ACCELERATOR ADVISORY PANEL REVIEW

CONVENTIONAL FACILITIES AND SITING GROUP

Single Tunnel CFS Aspects Cooling and AC Power Aspects

Response to AAP Review at TILC'09

Beamline "Arrow Diagram"

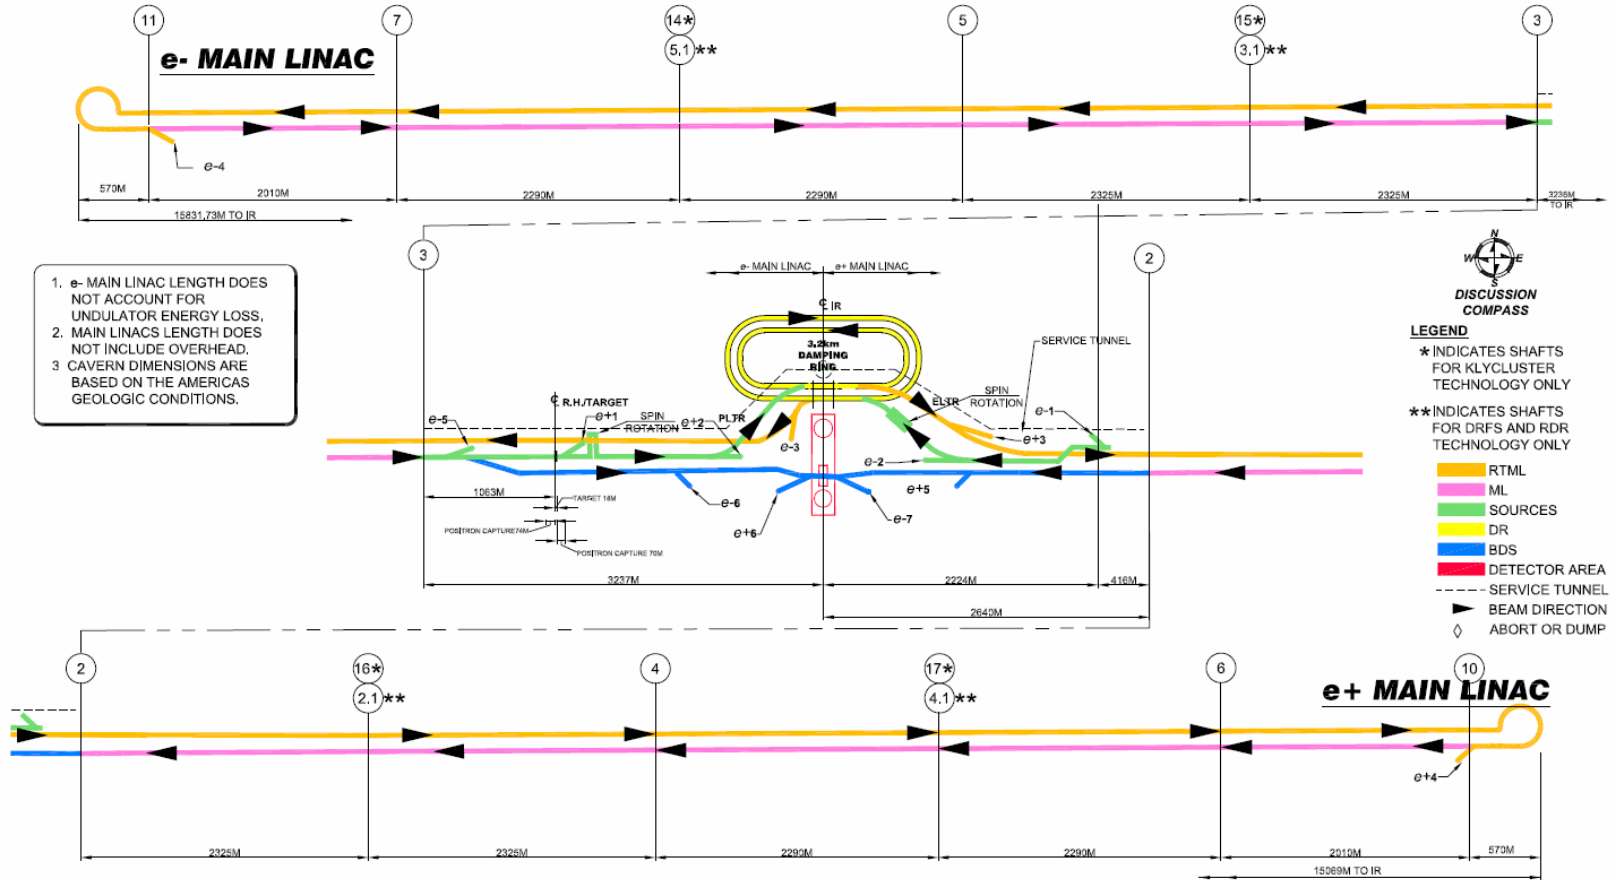
The AAP encourages further exchange between the various area groups. In many cases, guidance from the project managers is necessary for systematic application across the project. For these CFS efforts to be most useful, it is important to define clearly the main assumptions and technical choices

- **Since the Previous AD&I Meeting in May, 2009 the CFS Group has had Several Direct Meetings with the Various Area System Groups**
 - **CFS Weekly Video/Webex Meetings were Devoted to Specific Area Systems with AS Representatives**
 - **A CFS 2-Day Workshop was Held at SLAC in July, 2009**
 - **A Second CFS 2-Day Workshop was Held at the Daresbury Laboratory in September, 2009**
 - **Both CFS Workshops Allotted Time for Each Area System with Direct and/or Webex Participation with AS Representatives**
- **From These Meetings Criteria were Developed for the Layout of Each Area System and Combined into a Single Complete Machine Layout Which did Undergo Several Iterations**

- ***Norbert Collomb was the Main CFS Point of Contact to Collect and Combine all of the Area System Technical Criteria into a Complete Beam Layout***
- ***After Several iterations a Complete Technical Beamline Layout was Established in Mid-October, 2009***
- ***This Layout was Used by the CFS Group at FNAL to Develop the Final 2D Layout for the Tunnels and Enclosures to Match the Technical Beamline Layout***
- ***These Drawings Were Posted on the EDMS System in Mid-November, 2009***
- ***These 2D Drawings are the Basis for the On-Going 3D Drawing Effort***

European CFS Group 3D Drawing Examples

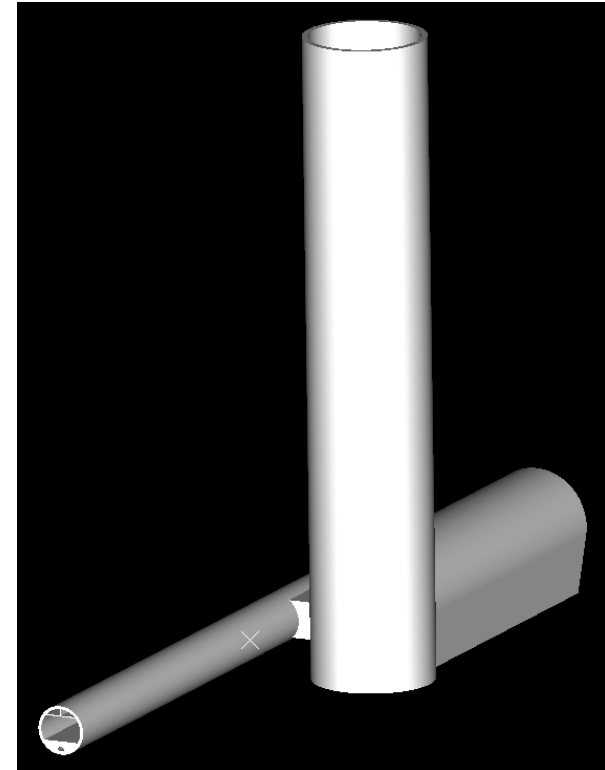
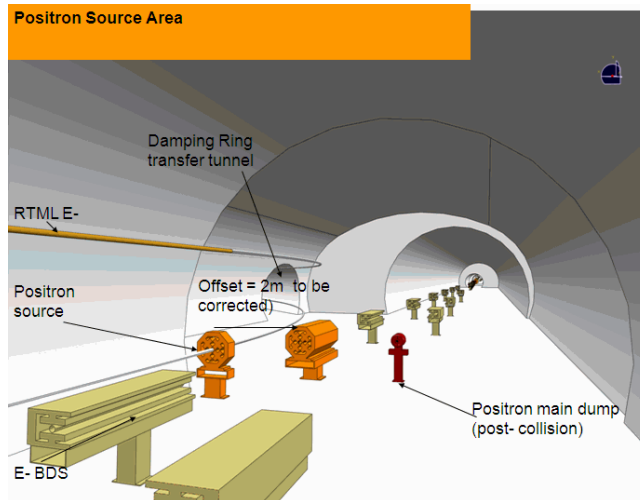
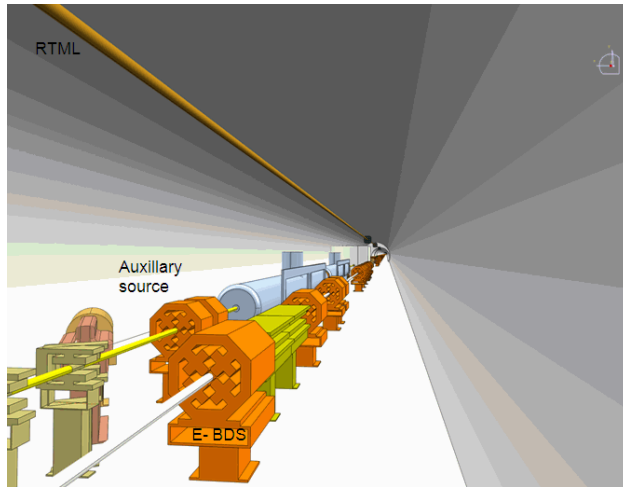
The AAP is impressed by the progress of the 3d tool integration. The tools are recognized as an important aid in understanding critical aspects of a chosen layout, where the benefits from the resource-intensive implementation efforts may be justified.

- The 2D Machine Layout Drawing is the Basis for the 3D CFS Enclosure Drawing that is Being Developed by the CFS Effort at CERN Using the European Cavern Configuration (More to Come on This Issue)*
- The 2D Machine Layout Drawing is also the Basis for the 3D Support Utility Drawings that are Being Developed by the CFS Effort at FNAL (M+W Zander)*
- 3D Drawings are Being Forwarded to DESY for Inclusion into the Complete ILC 3D Model as They Progress*
- Currently the Focus of the 3D Effort are Two 100m Sections of the Machine Layout as a Starting Point*
